Kevin Bilash  
US Environmental Protection Agency Region III  
1600 John F. Kennedy Boulevard  
Philadelphia, PA 19103

February 3, 2023  
File No. 4862.10

Re: Revised Responses to USEPA's October 13, 2022 and December 15, 2022 Comments  
Concerning the September 2022 IM Monthly Progress Report for AOI 7 in MHT

**GRAPHS OF TRANSDUCER DATA  
AND BORESCOPE DATA**

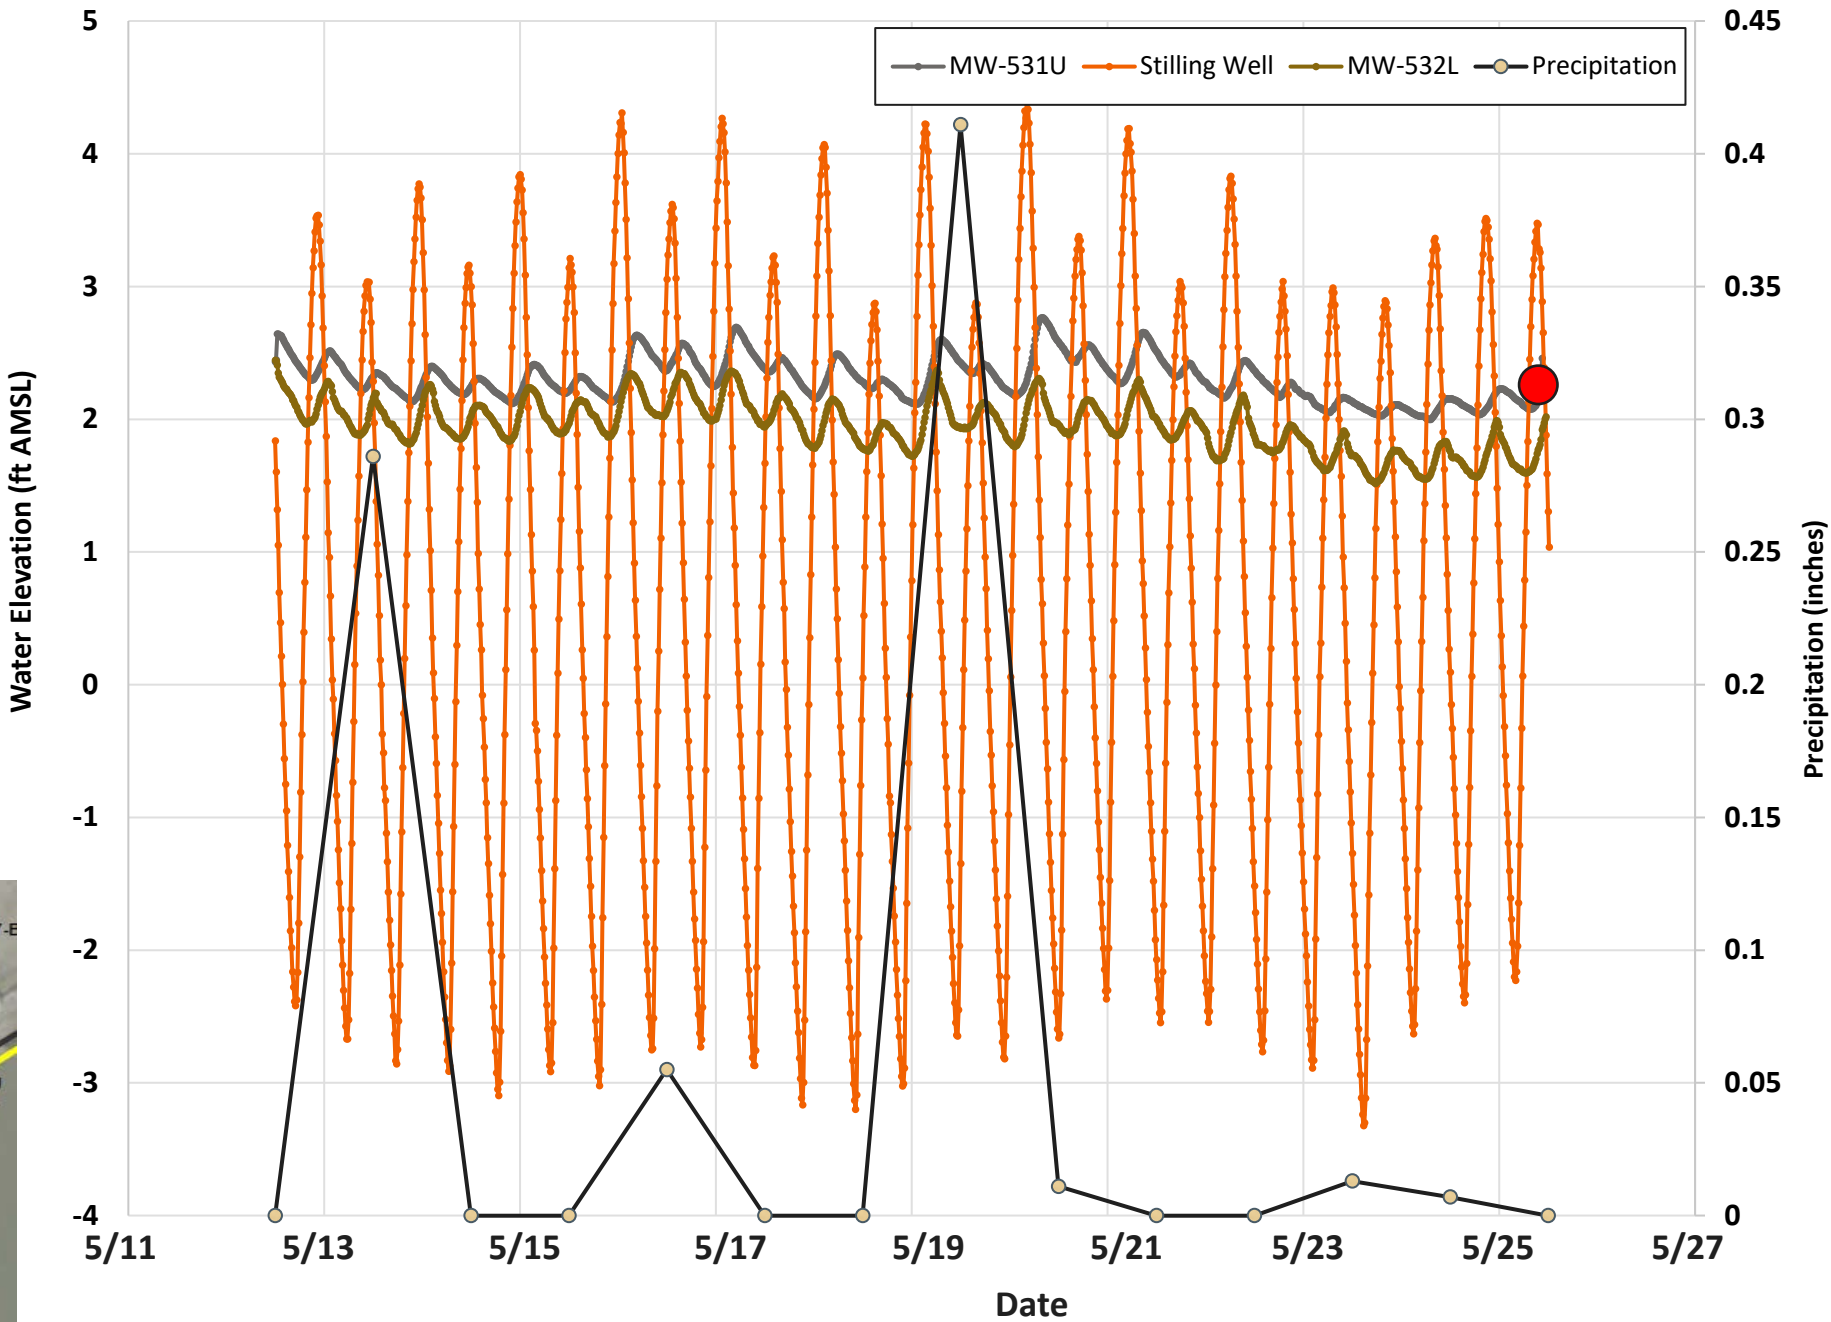
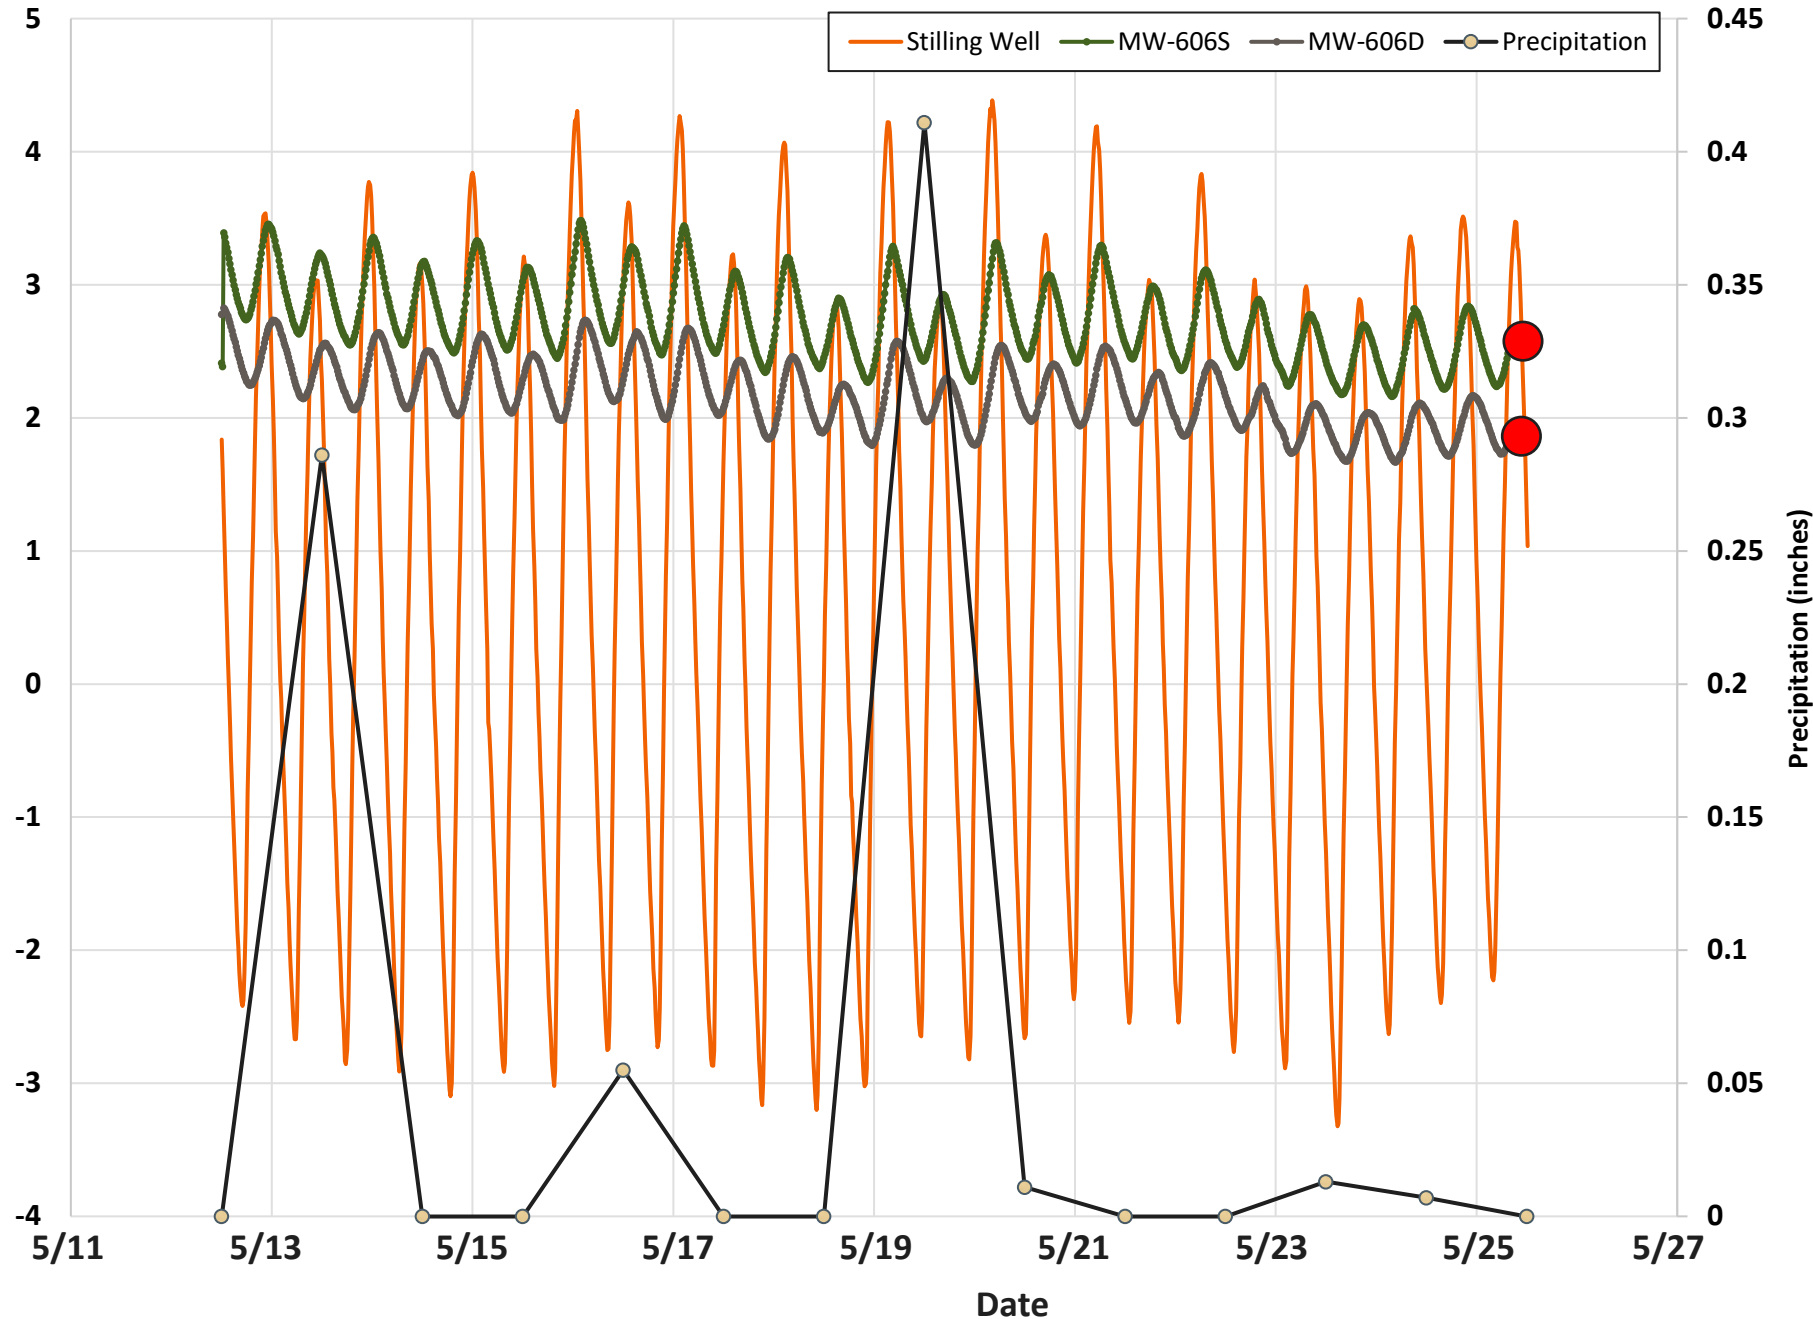
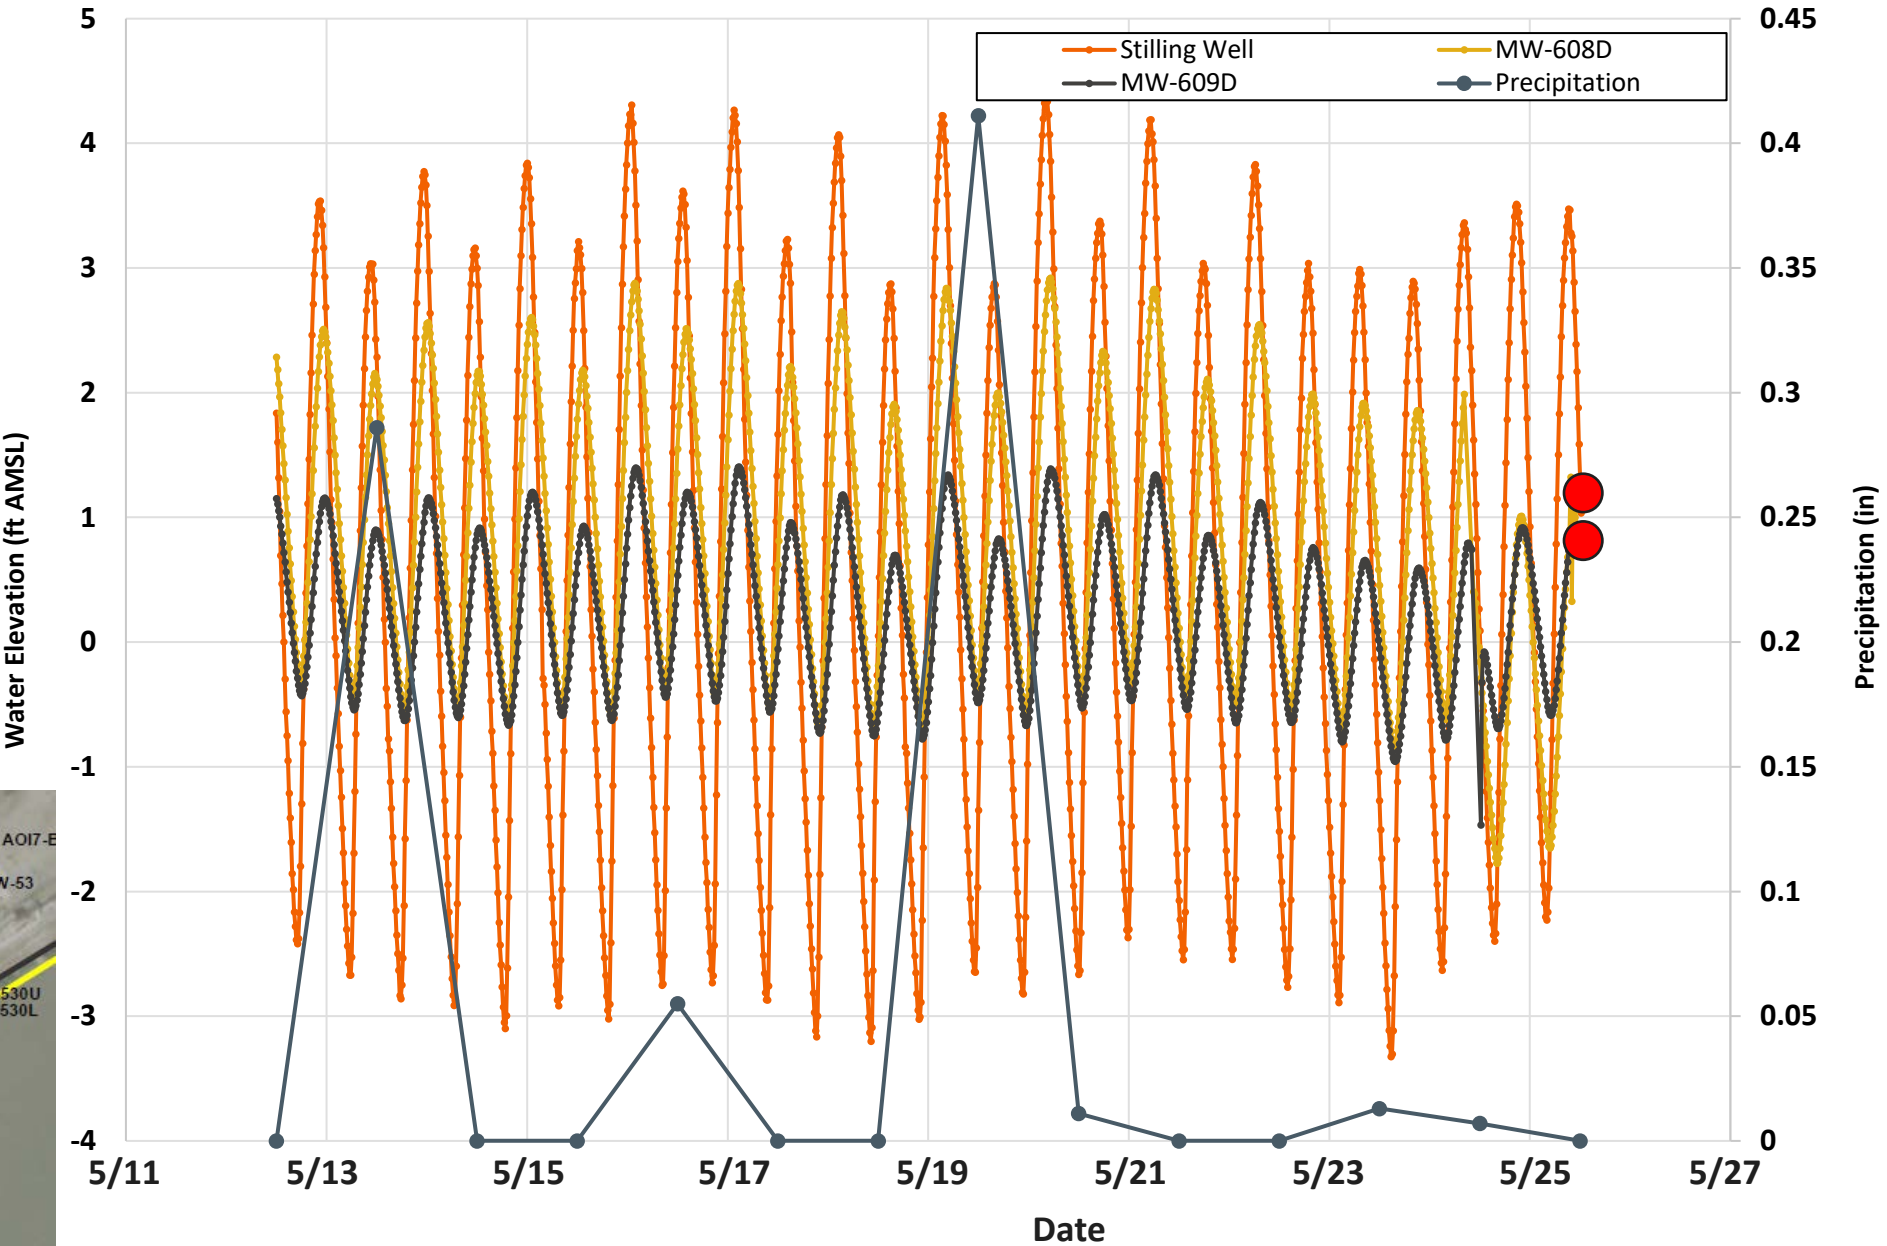
**Comment 8:** In the October 26, 2022 meeting EPA and Evergreen discussed the use of the colloidal borescope to evaluate the potential for preferential pathway within the silty sand strata and direction of groundwater flow in this zone. Has this data been evaluated and what are the results. Does it support the potential for preferential pathways as being evaluated in the draft arsenic precipitation calculations?

**Response to Comment 8:** The purpose of the borescope data collection was to compare and confirm groundwater flow direction with the pressure transducer data. The pressure transducer data collected in September 2022 in both the shallow and deep groundwater wells provided a unique point in time where all the water levels in these wells were measured during high and low tide to be able to generate representative groundwater flow direction to support the evaluation of potential preferential pathways at the site. Specifically, the pressure transducers were deployed in deep monitoring wells MW-56D, MW-509D, MW-530U, MW-531L, MW-532L, MW-534L, MW-558D, MW-559D, MW-560D, MW-606D, MW-607D, MW-608D, and MW-609D in the southern portion of AOI 7 to evaluate this potential preferential pathway. The borescope cannot collect groundwater flow direction data in multiple wells at the same time for a comprehensive data set. Instead, the borescope data was used to confirm groundwater flow direction at the time the borescope data was collected during the tidal cycle as shown in Attachment H. Because of the tidal influence at the site, the groundwater flow evaluation needs to be performed across multiple wells (shallow and deep) over a tidal cycle at the same time, which is not possible with one borescope, but was achieved with the pressure transducers.
